UNITED STATES OF AMERICA
NUCLEAR REGULATORY COMMISSION

In the matter of)	
COMMONWEALTH EDISON COMPANY)	Docket Nos. 50-295 and 50-304
(Zion Nuclear Power Station,)	
Unit Nos. 1 and 2))

EXEMPTION

Pressurized Thermal Shock (PTS) Evaluation

Figure 1 - **WF-70 Initial RTndt Determination**
 B&W Dynamic Data/ORNL Crack Arr. Data

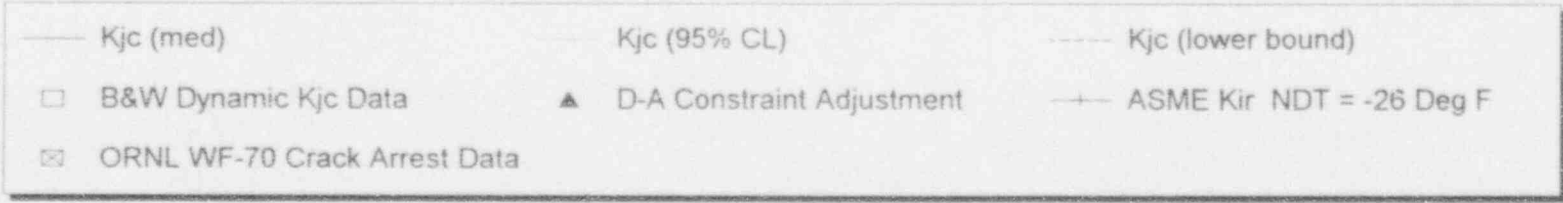
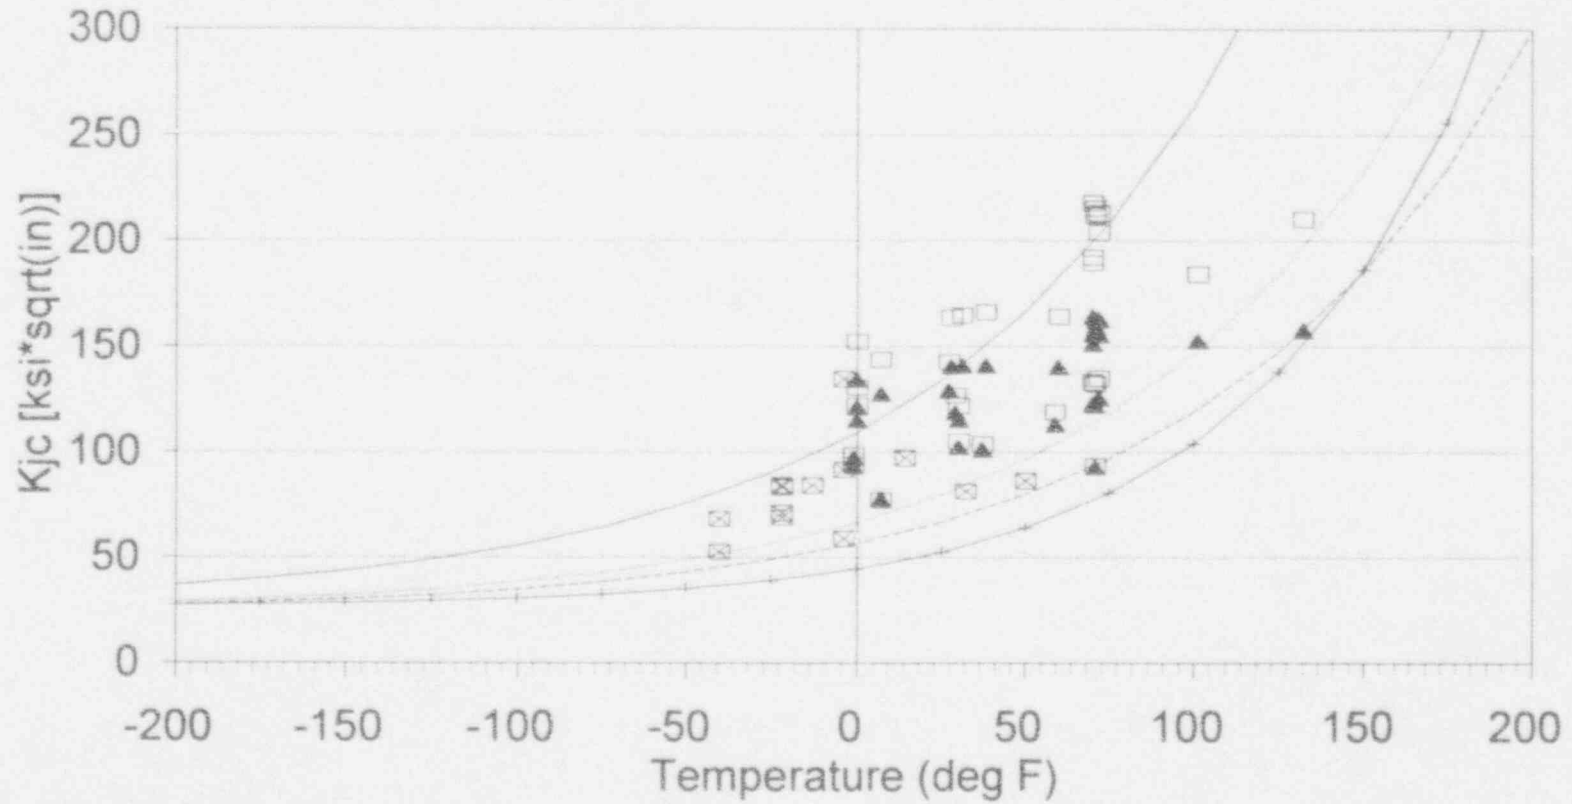
The staff has independently evaluated the data provided in BAW-2202 and the previous report (BAW-2100, January, 1993) in accordance with the Draft ASTM Standard on Fracture Toughness in the Transition Range. The staff analysis, presented in the attached Figure 1, considered both constraint and rate effects on the data. Figure 1 presents the B&W dynamic fracture

toughness data as the open symbols. The solid symbols represent the same data constraint corrected using the procedure suggested by Anderson and Dodds, 1993. The ASTM curves (K_{Jc} median, 95% CL and lower bound) were derived from the constraint-corrected data at 0°F where it can be seen that the magnitude of the correction was small. It is seen that the ASTM K_{Jc} lower bound curve effectively bounds all of the data with the possible exception of the constraint-corrected point at +132°F. However, the specimen at +132°F exhibited a significant amount of ductile tearing prior to failure by cleavage. It is known that the Anderson-Dodds procedure will "over-correct" for constraint in such instances.

With respect to strain rate effects, the B&W dynamic data were generated at a rate of approximately 7×10^4 ksi√in/sec. This rate is on the threshold of the rates achieved in the crack arrest tests which constitute the ASME K_{IR} curve. Figure 1 also shows a direct comparison between the B&W dynamic fracture toughness data and some recently available crack arrest data on WF-70 from the ORNL. While the crack arrest data are generally conservative in comparison to the B&W data, it is seen that the ASTM K_{Jc} lower bound curve also bounds the ORNL data. On the basis of this analysis, the staff finds the methodology of indexing the B&W dynamic data to the K_{IR} curve acceptable.

In conclusion, the staff analysis which addresses constraint and rate effects has shown the fracture toughness based procedure for determination of unirradiated reference temperature to be acceptable for WF-70. As shown in Figure 1, the ASME K_{IR} curve, with a reference temperature of -26°F bounds all of the constraint-adjusted data and the ASTM curves up to approximately 140°F.

This analysis therefore supports an unirradiated reference temperature of -26°F for the WF-70 material.
